DESCRIPTION: **Auxiliary BLDG. CRANE**

AEPC NO. **DC112cmH-117-717-002**

TITLE: **30 TON OPEN BLOCK APERTURE**
REPORTS: **BORE**

T-49576

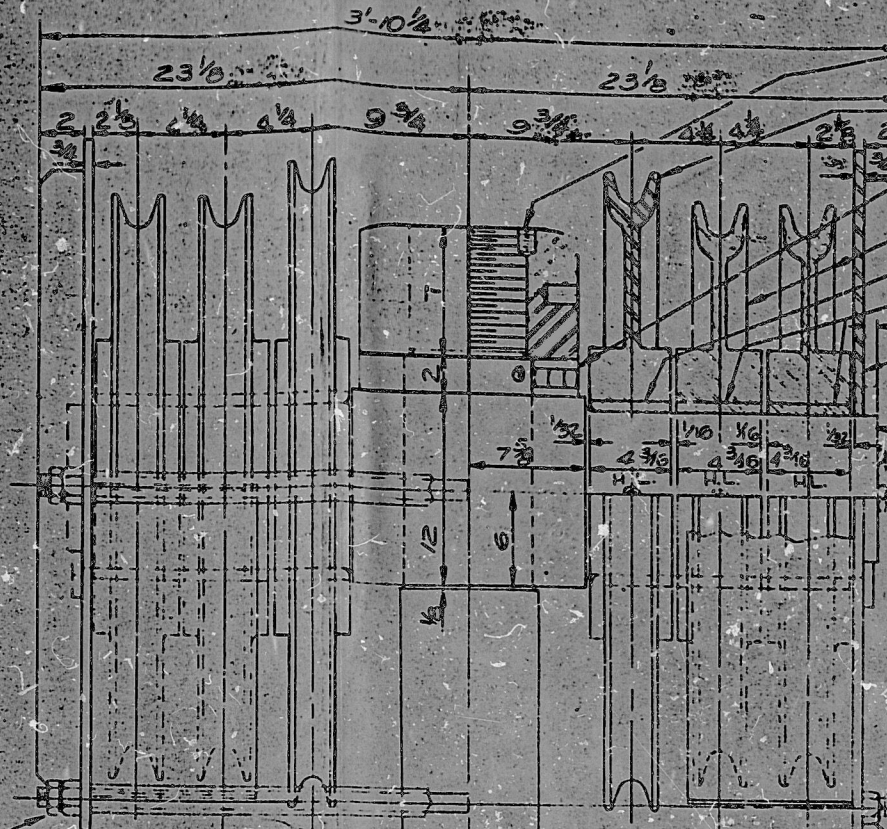
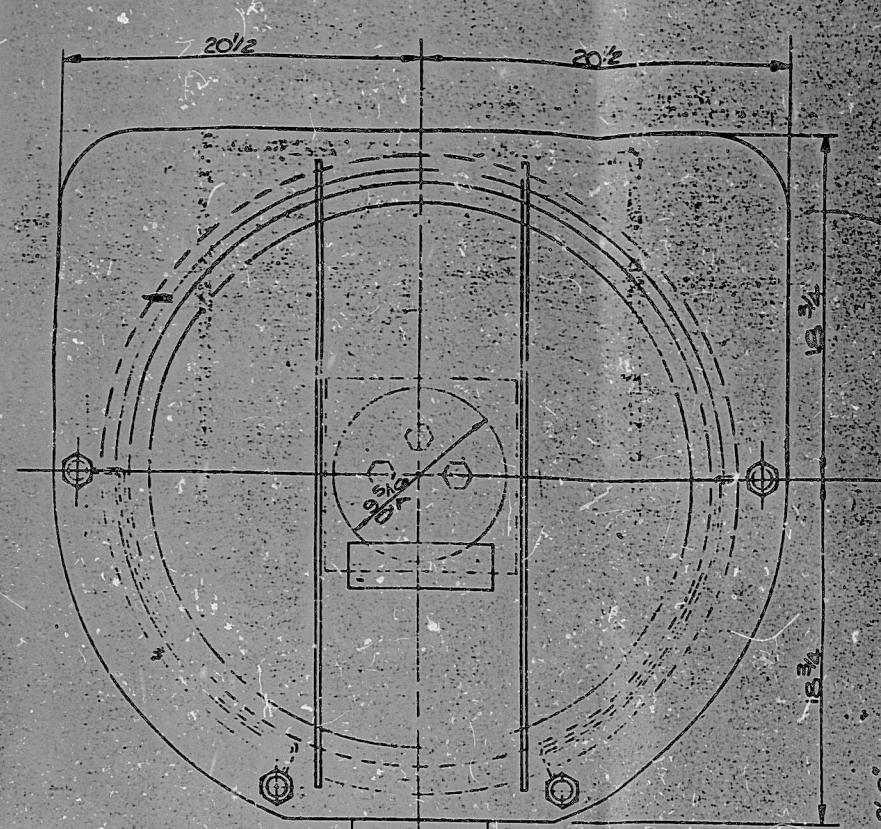
NOTE: - ON SYM. C, "AE" WAS CHANGED FROM A BRONZOID THRUST BRG. TO A STAINLESS STL. ROLLER THRUST BEARING ON REQ'N 77358-5/84. 1" THICK SPACER MUST BE REMOVED FROM NUT (GRIND TACK WELD)

30 TON LIFTING EYE S-63056 WITH NUT-USED FOR ONE TIME CONSTRUCTION LIFT. SEE NOTE ON G/A U-61740 FOR ADDITIONAL DATA.

| | | | | | | DF FROM BRG. CO. STAINLESS STL. ROLLER THRUST BEARING (EQUIV. 70-TP131) |
| | | | | | | SEE TROLLEY/A U-61740 FOR LUBR INSTRUCTIONS DURING & AFTER CONSTRUCTION PERIOD. |
